RC 3615 Magnetic Tape Transport
Supplement to the PERTEC Manual

Abstract : This paper contains a modification diagram the PERTEC 6640-98
dual density transport.

Modification diagram to "Schematic
Diagram Tape Control C2" PERTEC
DWG. No. 101881

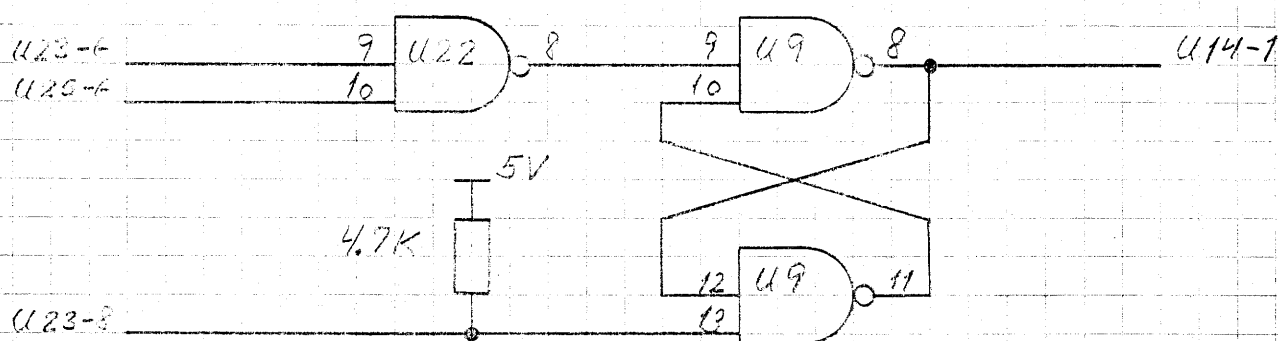
The print circuit is broken between U15-5 and
U14-1-2

U14-1 has to be found in drawing sector 15

U23-6 — — — — 20

U23-8 — — — — 20

U25-6 — — — — 26
